NOTICE: Final Plan Revision for Traffic Calming on Fulmer St (Miller Ave to Foss St)

REVISED Final Plan - Fulmer Street (Miller Ave. to Foss St.)

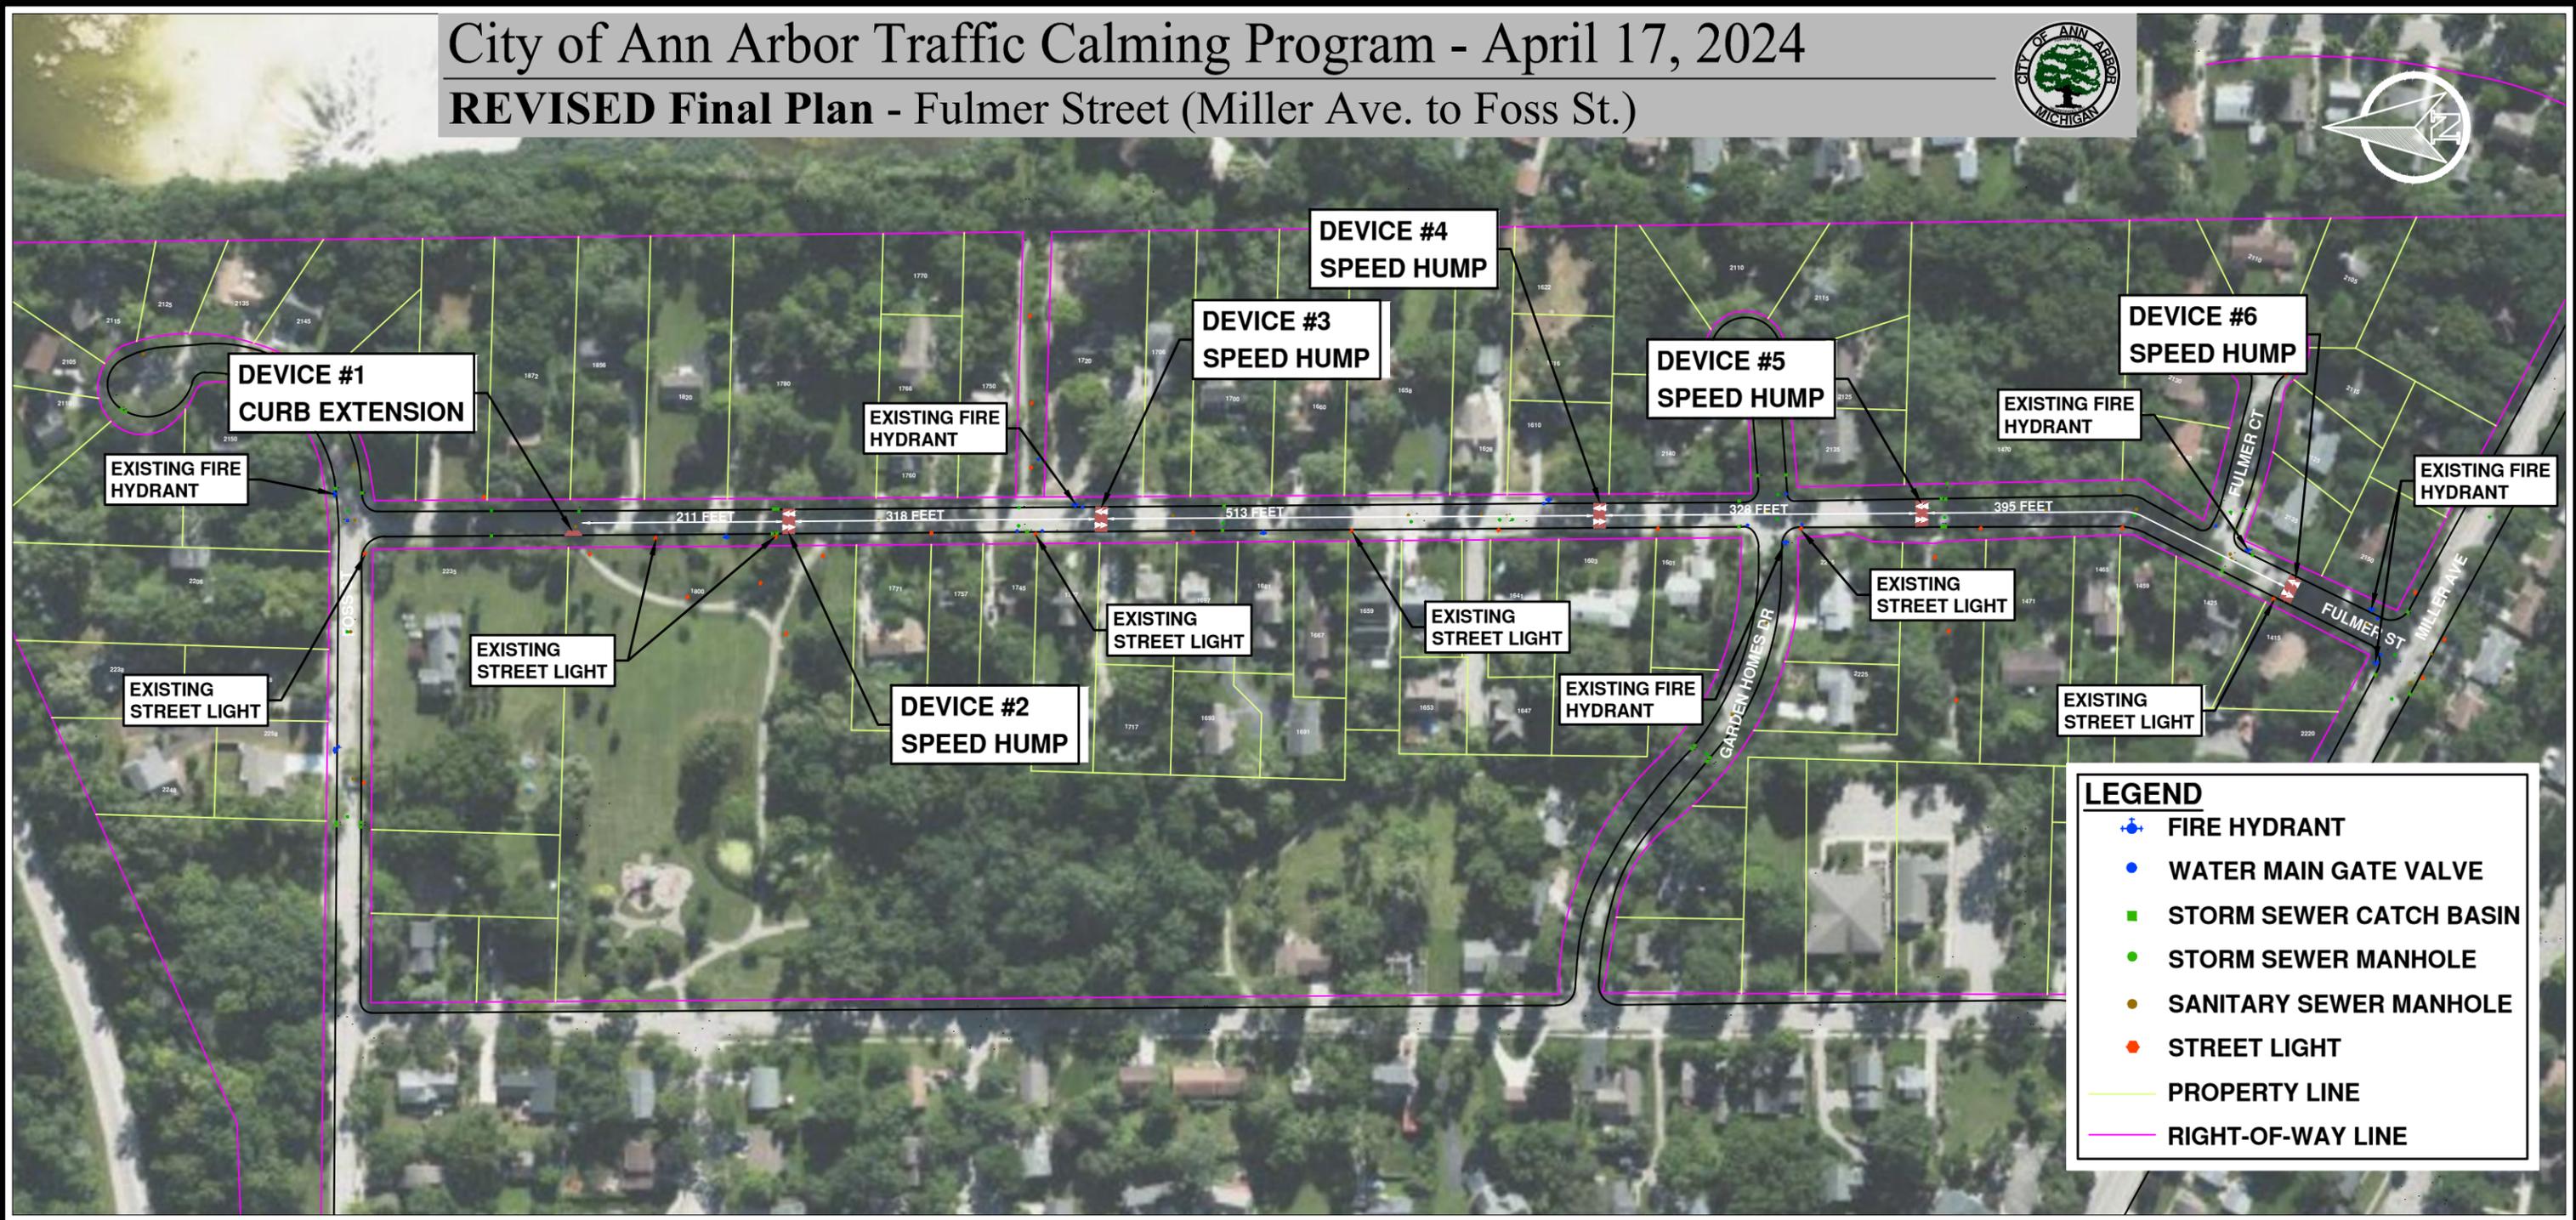
Due to the technical challenges installing raised crosswalks, the final plan for traffic calming on **Fulmer St from Miller Ave to Foss St** has been slightly revised, see reverse for revised plan. The following two (2) devices have been modified:

Device 2 – Raised Crosswalk will become a speed hump which will be located just north of the crosswalk.

Device 3 – Raised Crosswalk will become a speed hump which will be located just south of the proposed crosswalk.

It's the city's responsibility to make sure all crosswalks are compliant with Americans with Disabilities Act (ADA). Due to the geometry of Fulmer St it is unachievable to install the raised crosswalk in a manner that would reduce speed and be American with Disabilities Act (ADA) compliant.
